VOLVO

February 13, 2006

NVS-213dlr
PE05-057

This letter and its enclosures comprise the response of Volvo Cars of North America, LLC (VCNA) to your request for information relating to Preliminary Evaluation PE05-057 received on December 1, 2005. VCNA was granted a request to answer PE05-057 by February 15, 2006.

6-cylinder:

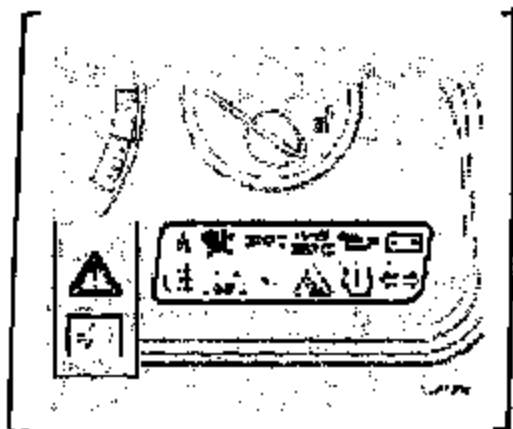
There was an error in the factory assembly instruction. The B+ terminal may be in conflict with the starter motor solenoid. If this occurs, the conflict between the B+ terminal and the starter motor solenoid may develop into a short circuit of the battery cable to ground. This can be noticed by the customer in different ways. If the vehicle is parked, smoke may appear from under the hood and/or it may be impossible to start the car. If the short circuit happens during driving, electrical power could be lost, resulting in warning lamps being deactivated. Volvo has decided to have a recall for this (Recall 150, NHTSA Recall 05V-529 per Defect Notification Letter dated November 18, 2005 enclosed.)

This can be noticed by the customer in different ways. If the vehicle is parked, smoke may appear from under the hood and/or it may be impossible to start the car. If the short circuit happens during driving, electrical power could be lost, resulting in warning lamps being deactivated.
